**ADDENDUM NO. 3**

IRONDALE FIRE STATION No. 3

THIS ADDENDUM FORMS A PART OF THE CONTRACT DOCUMENTS. THE FOLLOWING CONDITIONS TAKE PRECEDENCE OVER ANY CONFLICTING CONDITIONS IN THE DRAWINGS AND SPECIFICATIONS. THE DRAWINGS AND SPECIFICATIONS ARE HEREBY AMENDED IN THE FOLLOWING PARTICULARS.

**C5.4**

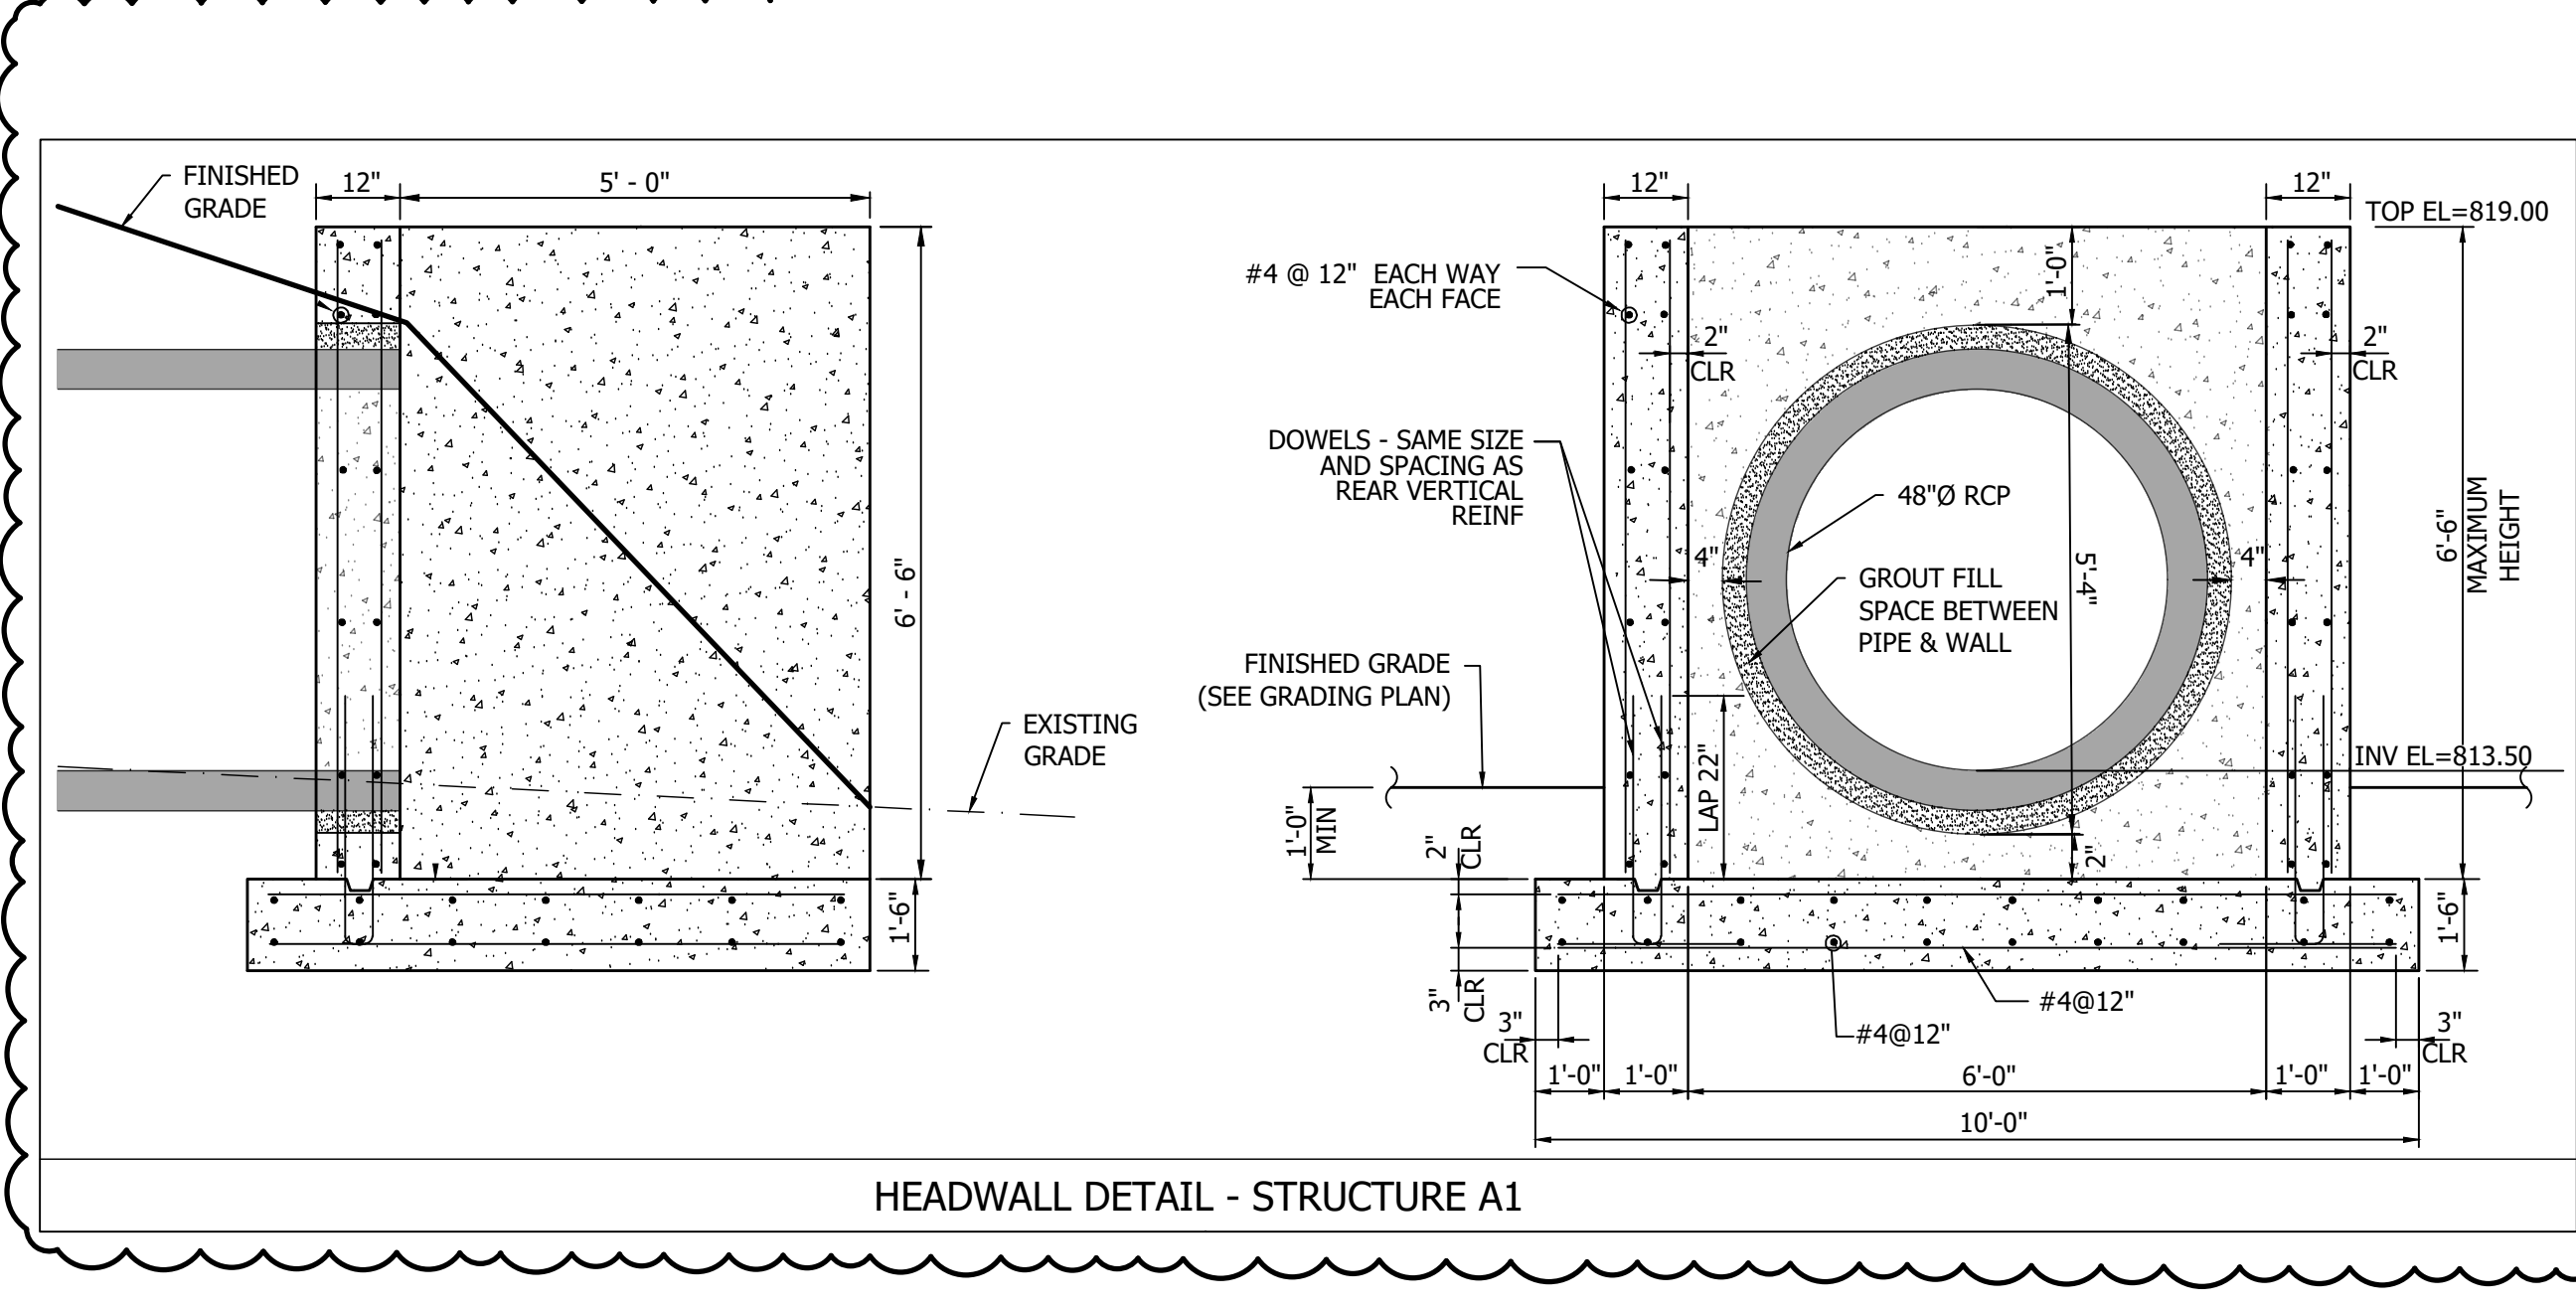
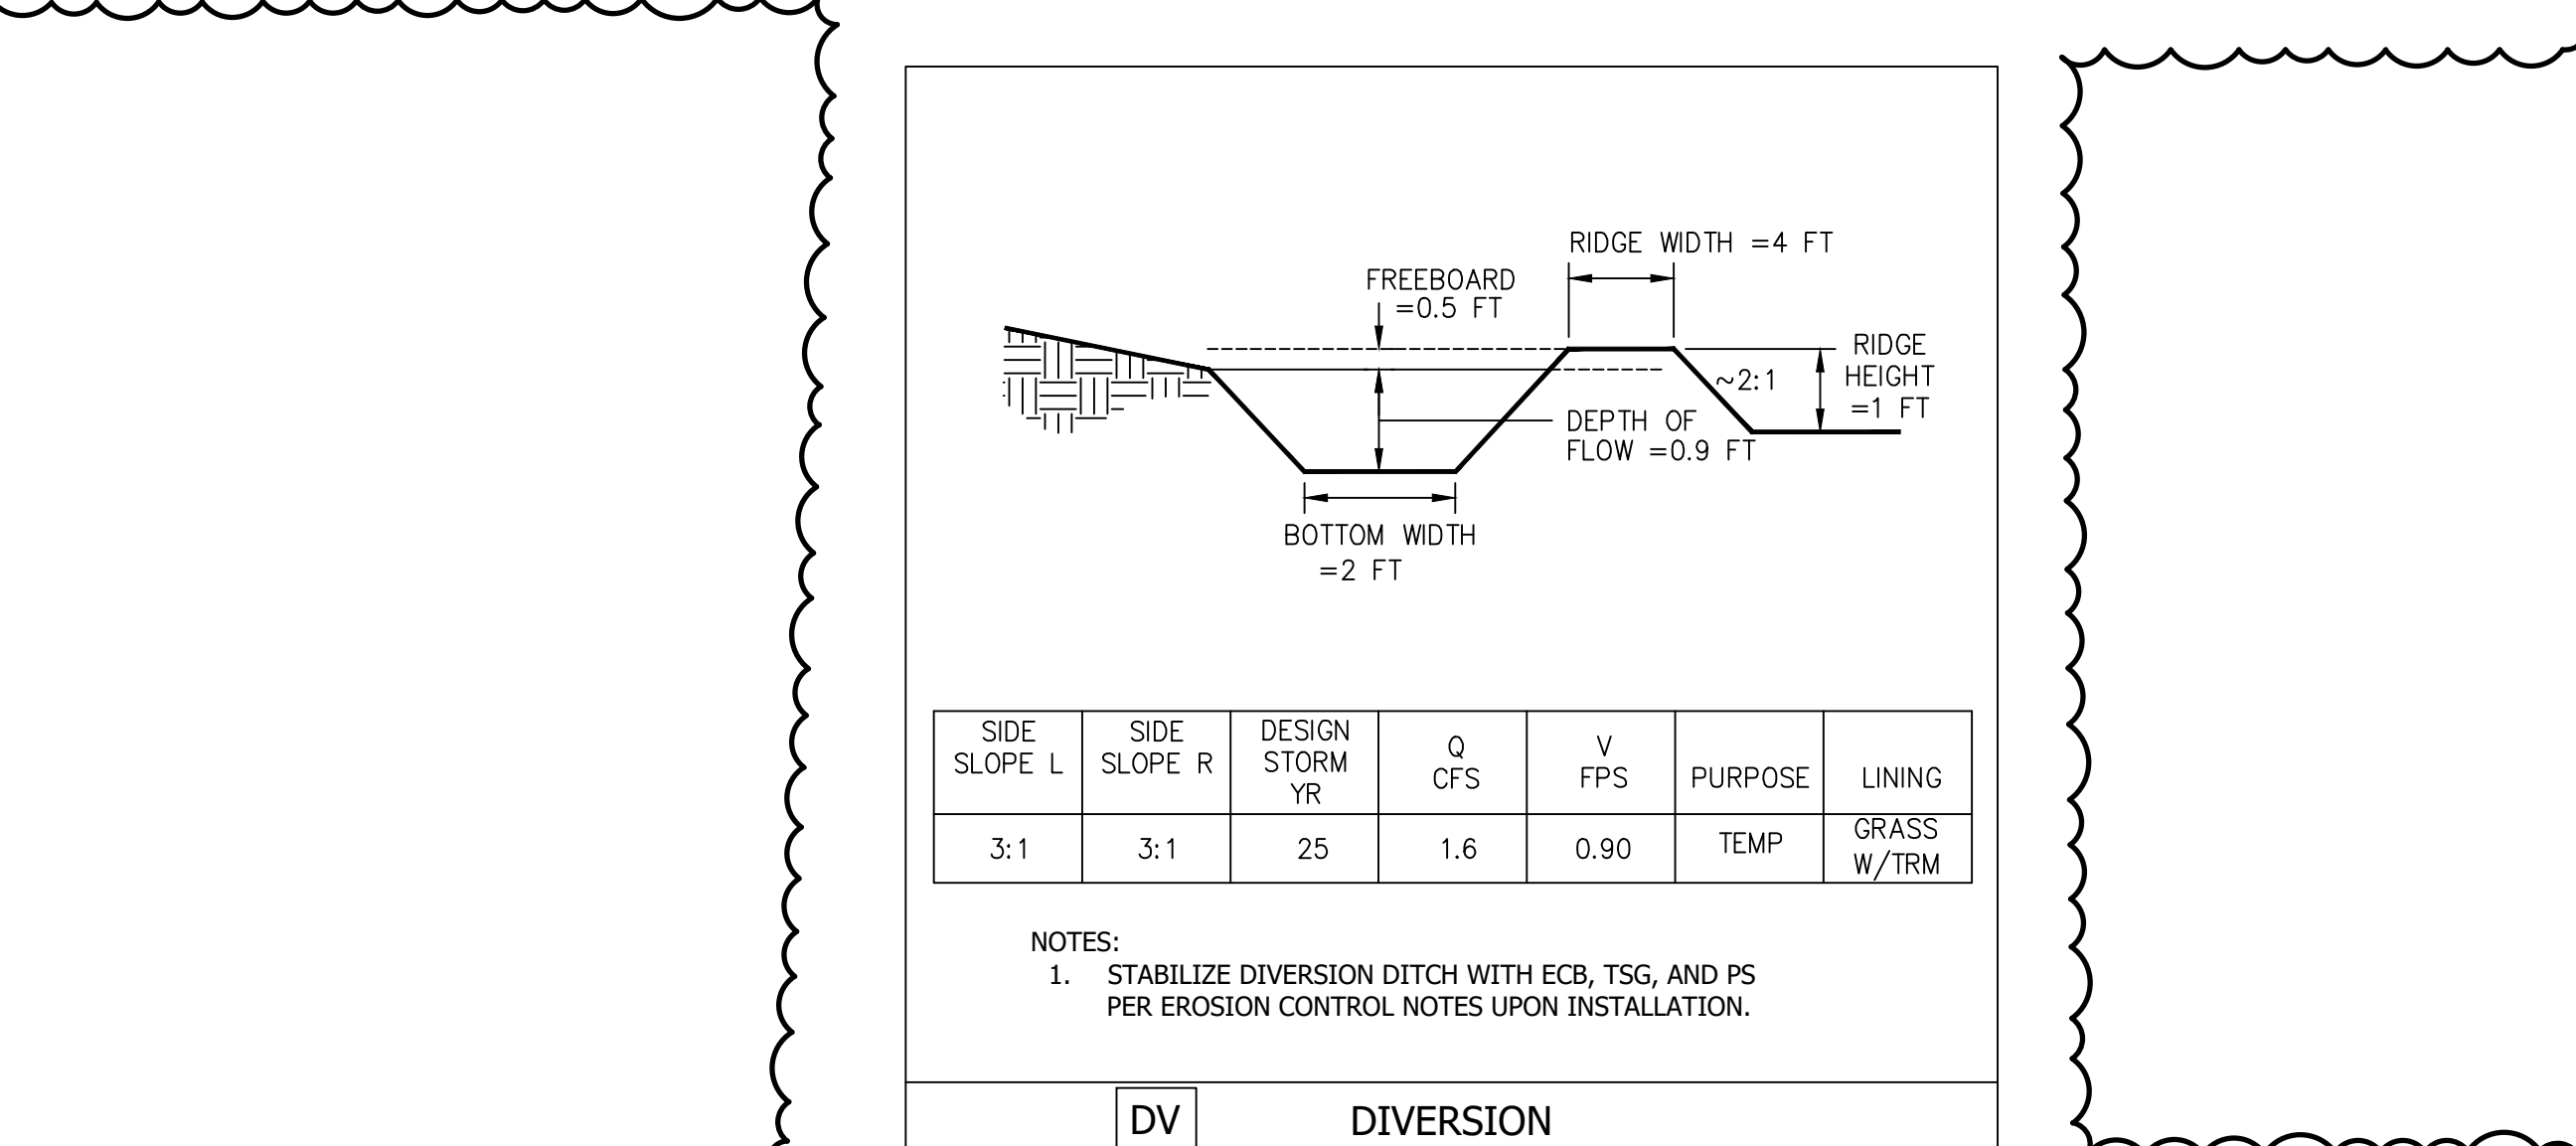
8. C5.4 Details:
- a. Added mulching, temporary, and permanent seeding detail
  - b. Added diversion berm detail
  - c. Added Headwall detail for structure #A1
